ADDENDUM NO. 11

PROJECT TITLE - PA State Police Greensburg - DNA Laboratory Facility New Building

ADDENDUM 11

MEP REVISION #1 - 11/15/2022

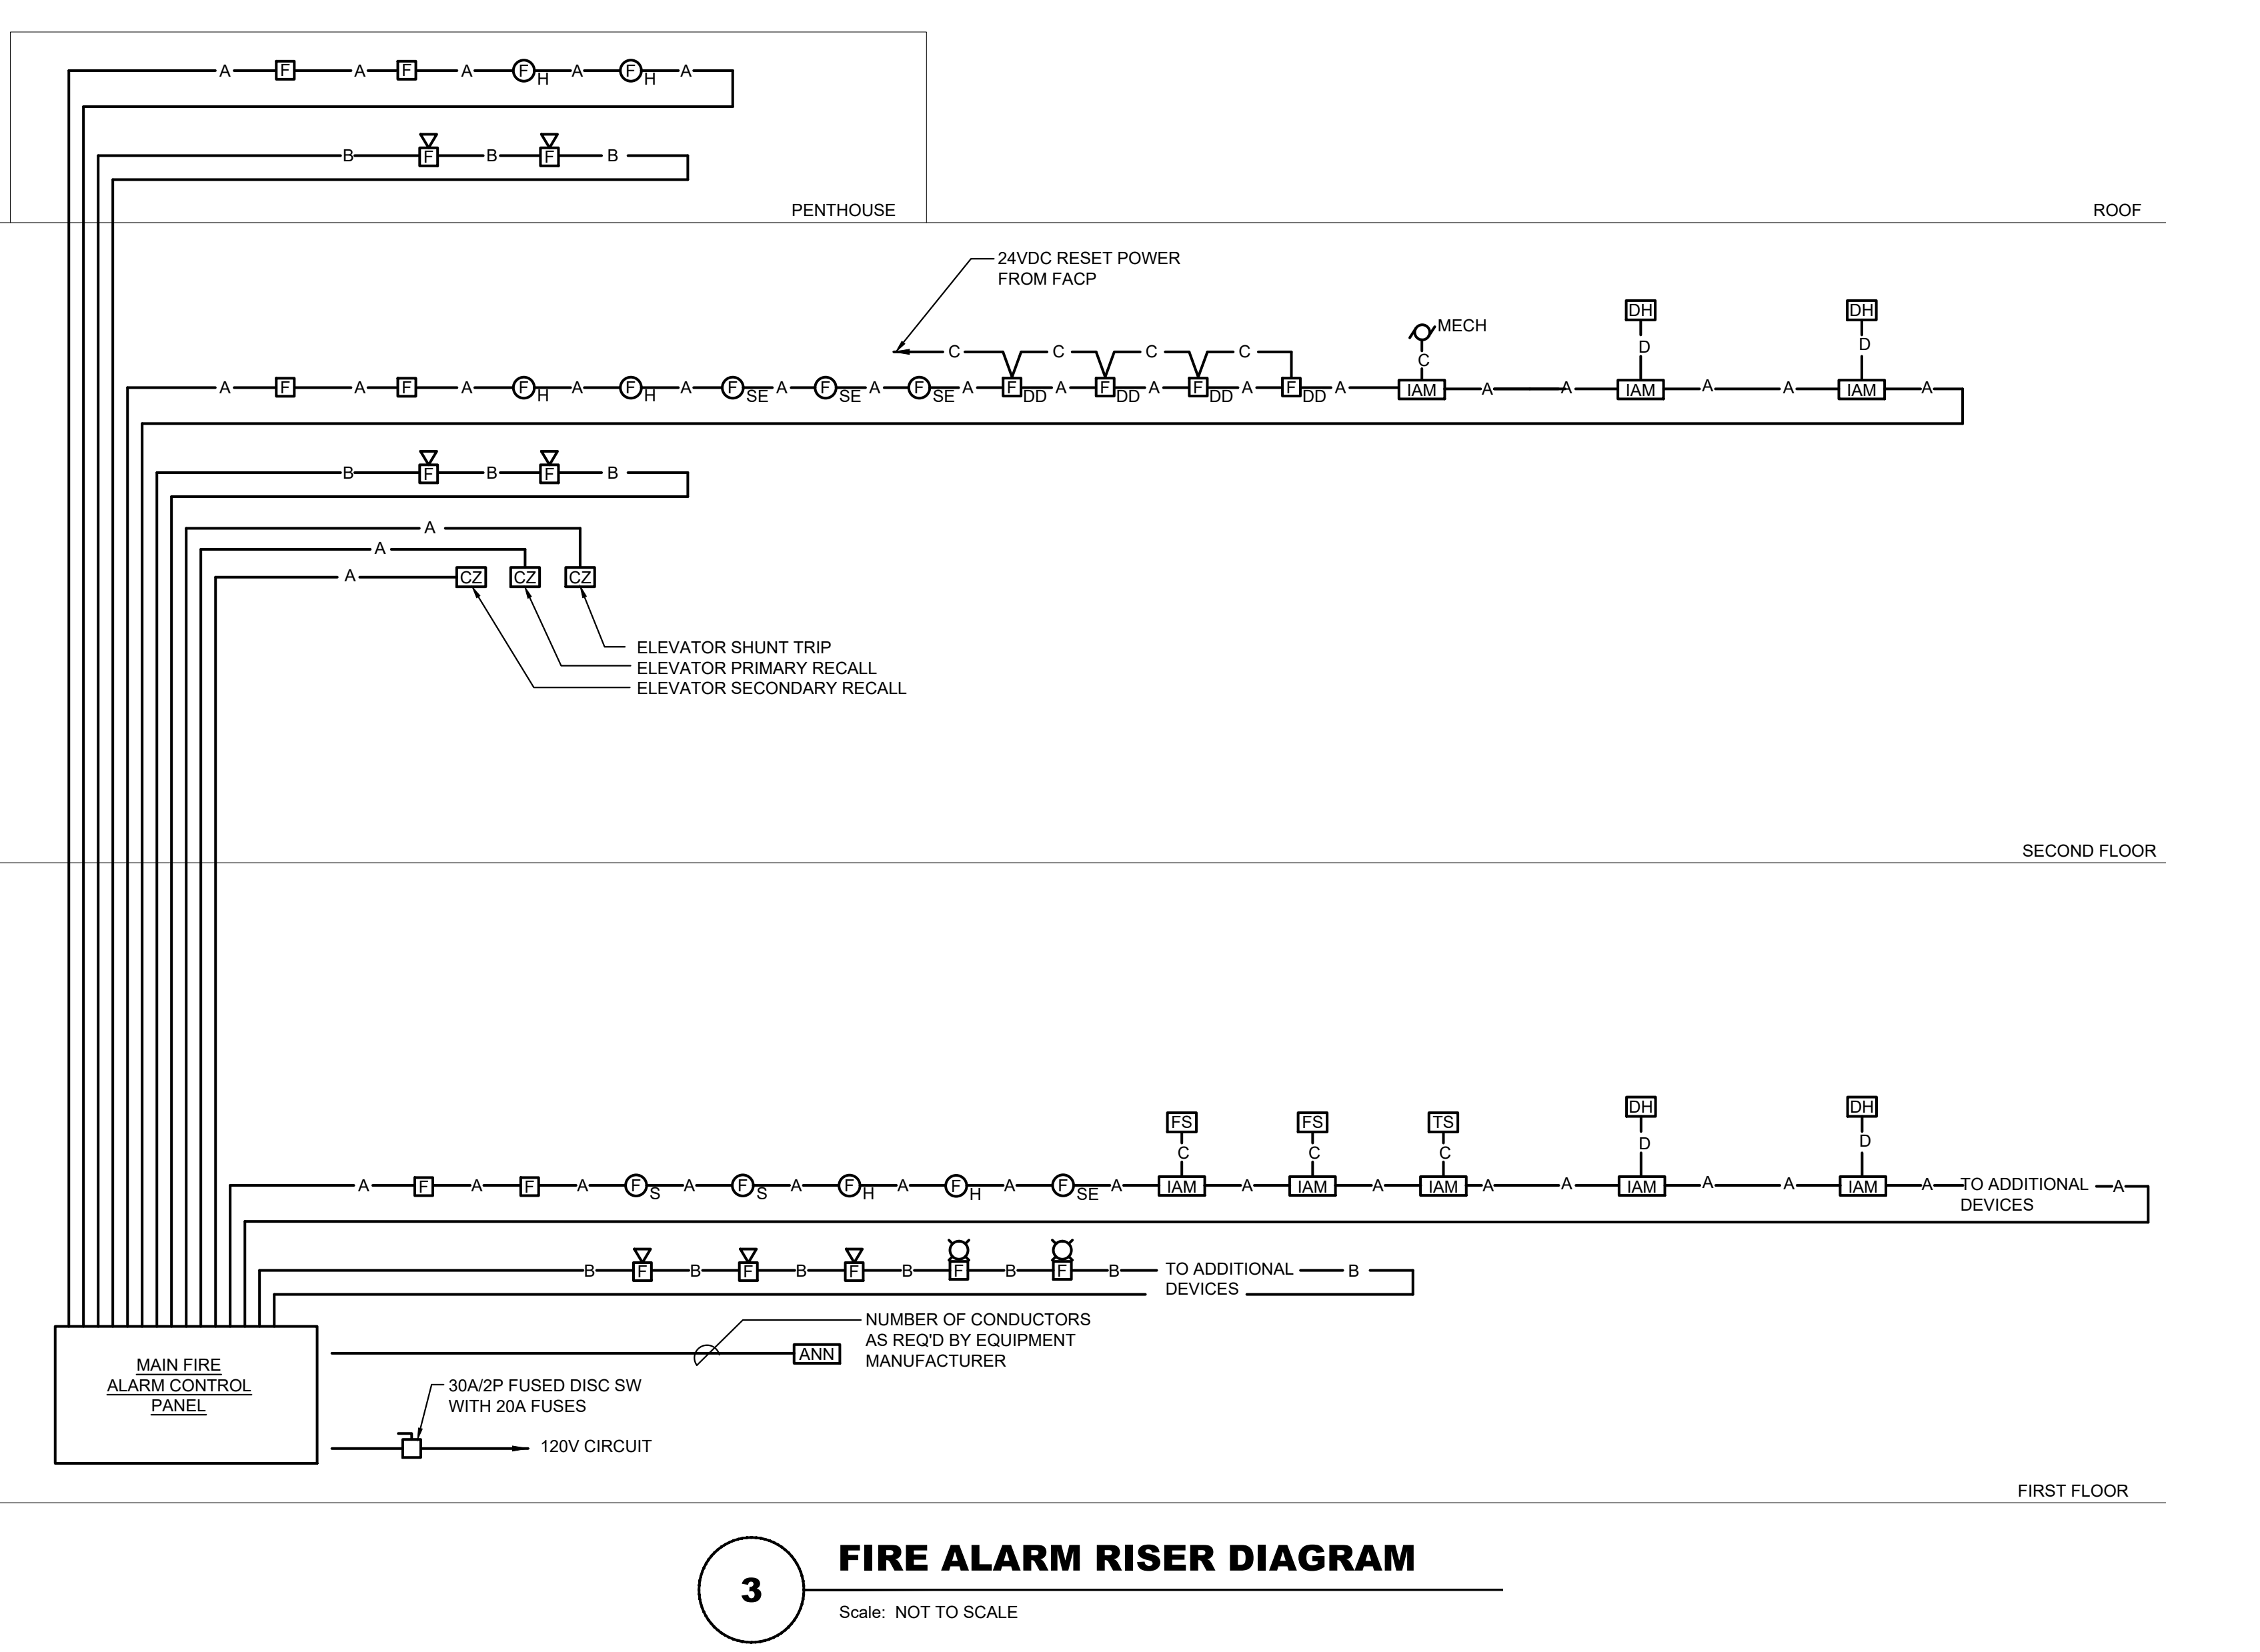
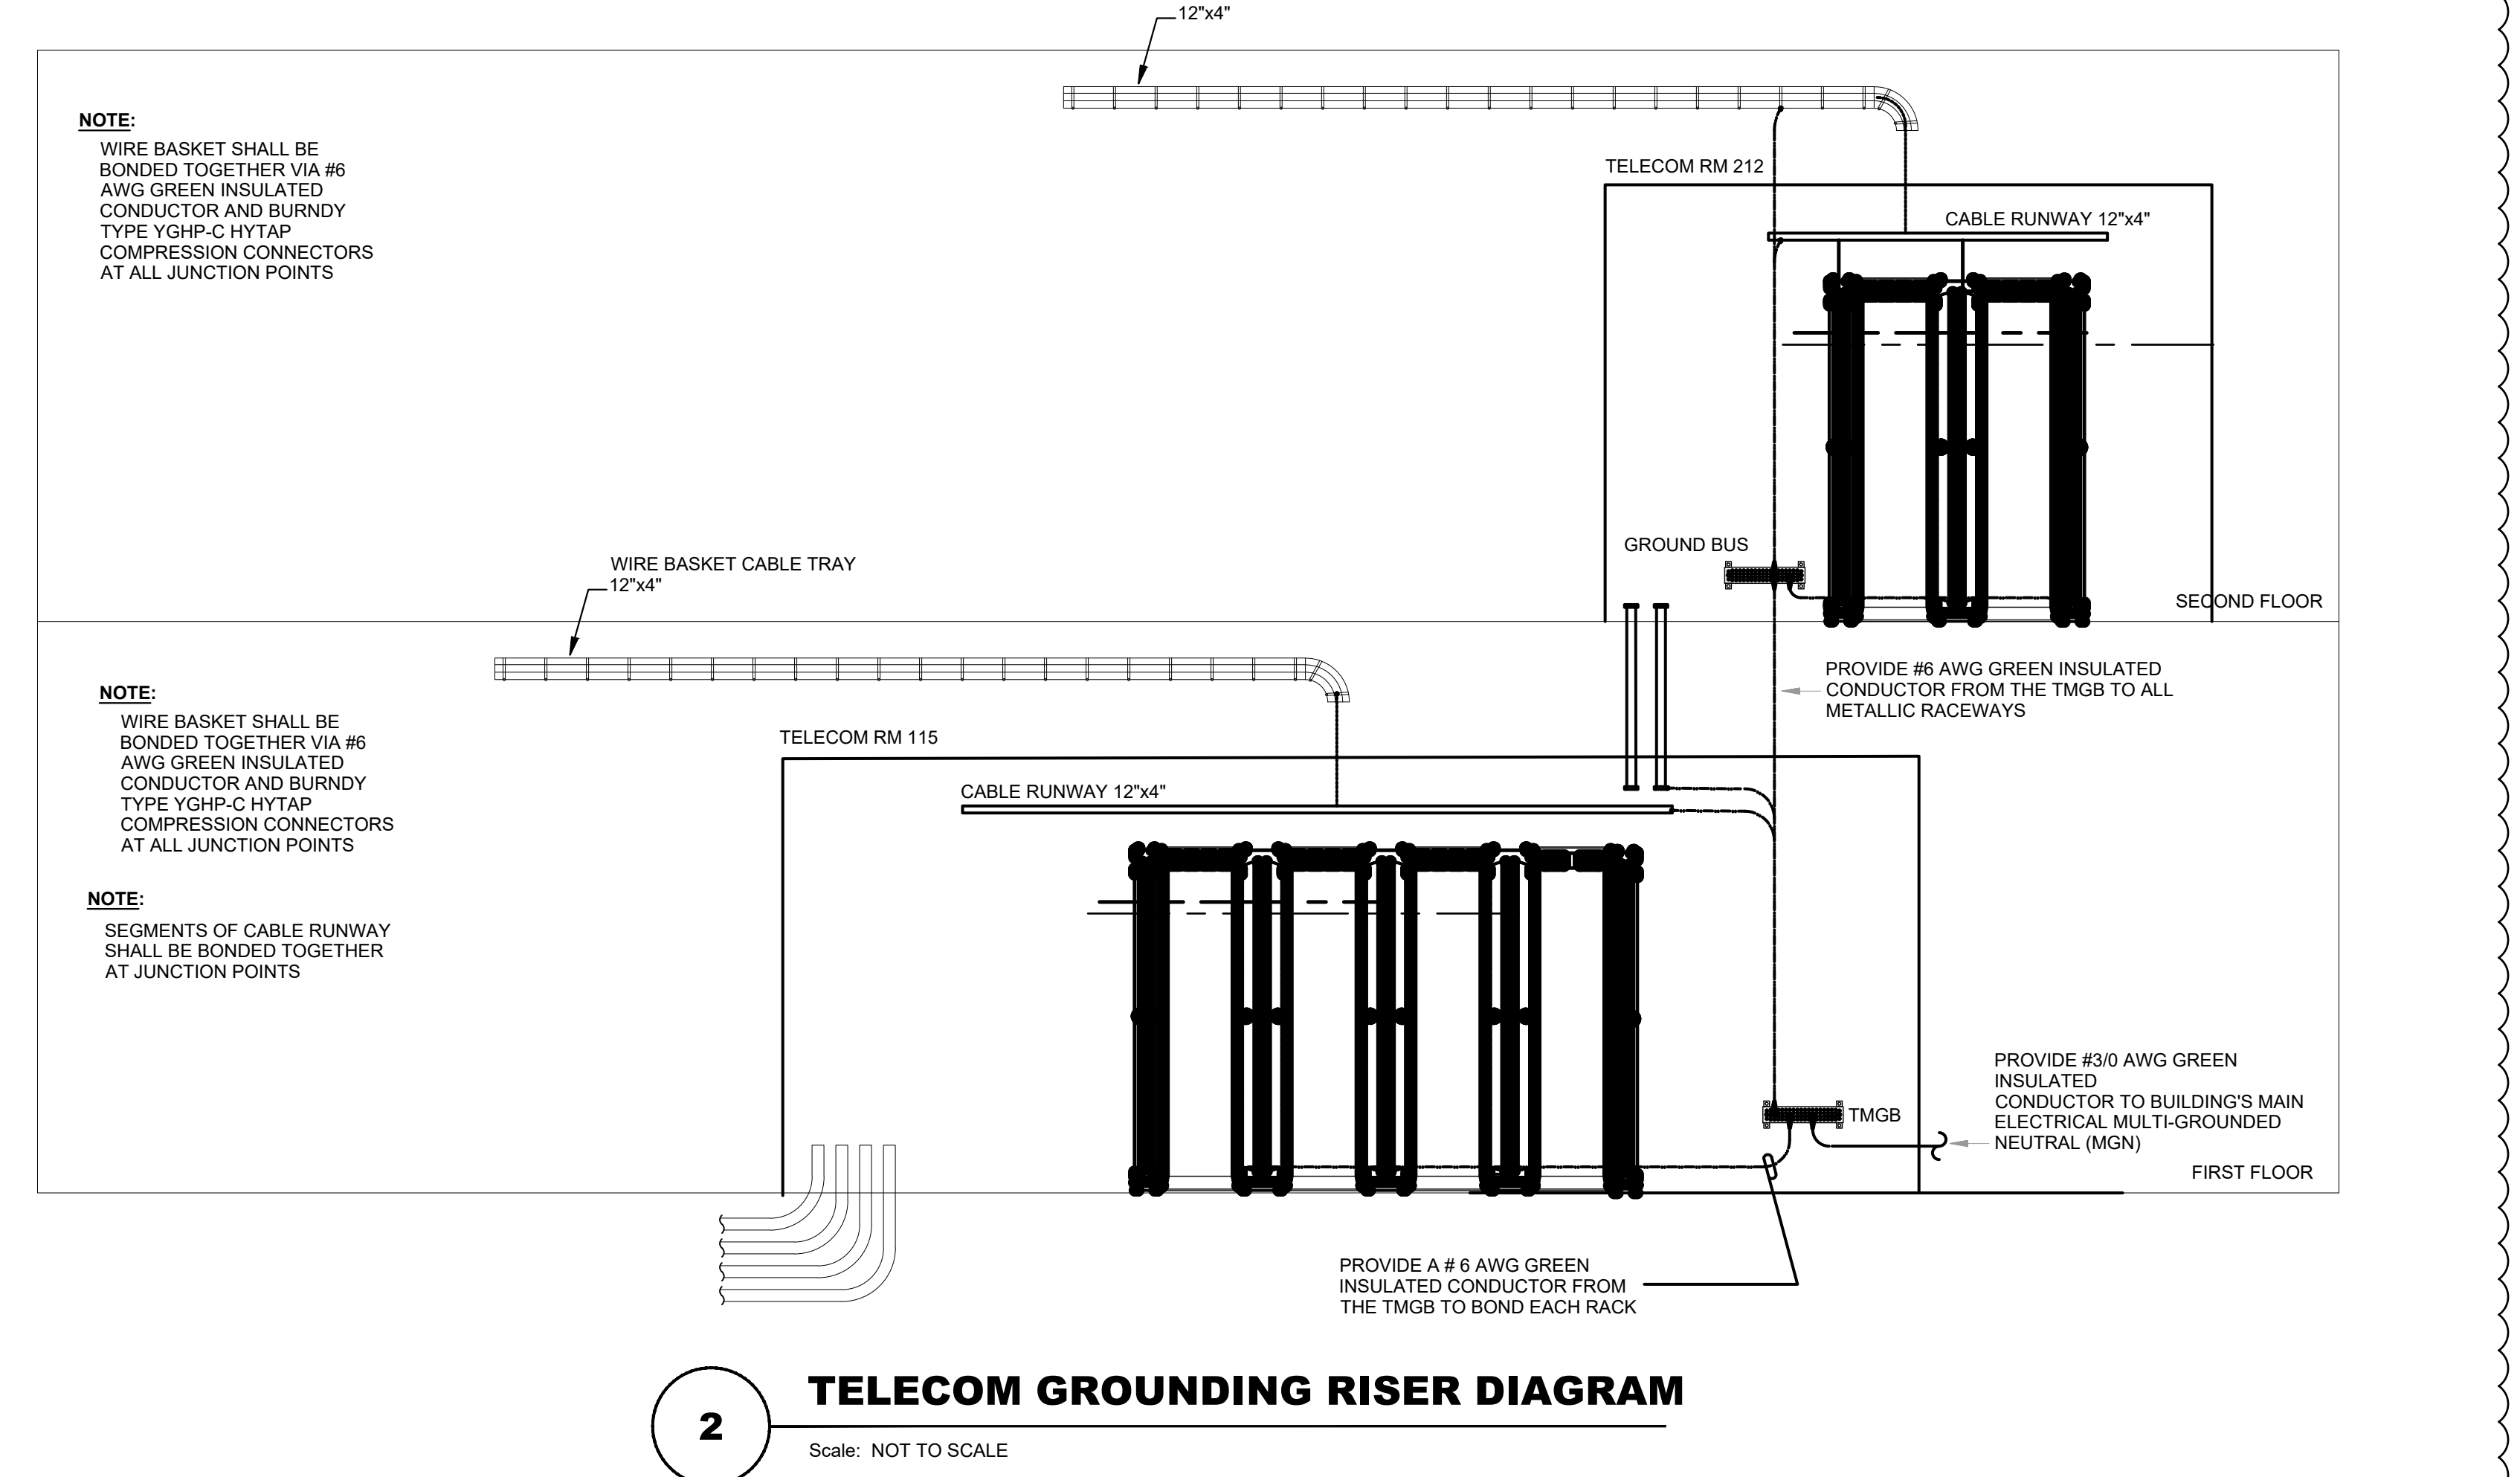
.4 Contract - RFI 01	10.25.2022 01:09 PM	Jim Clark, TSB Inc. d/b/a Schultheis Electric	Floor Boxes: Can you provide a manufacture and catalog number for the floor boxes shown on drawing E111P, E114P, E111S, and E112S?	See revised sheet E605, attached to this addendum	11.14.2022

E605 - Added "Floor and Pedestal Table Box Schedule".

E605 - Added light fixture 'S1' to schedule.
